Product Change Notification

1. ECR #: 25-40665-1
Notification #: 806

- HS-QSFP - null
- HS-103 - null

- HS-QSFP-P1-XX

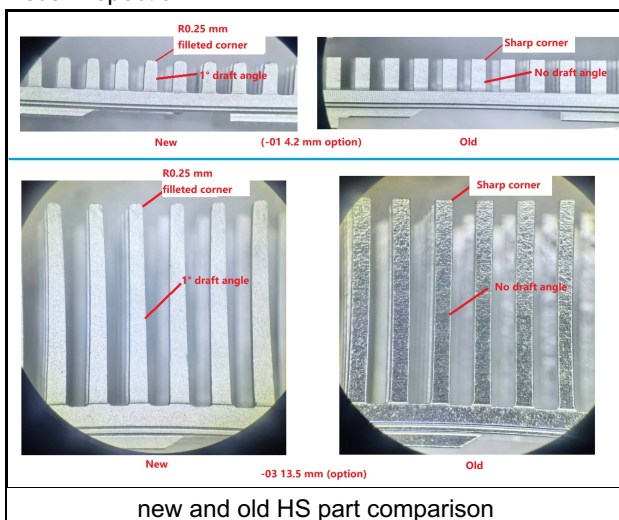
Pin shape change due to filleted corner and draft angle added.

CNC machining replaced by aluminum extrusion to improve manufacturability, this will be an rolling change.

- Form - This will be a form change.
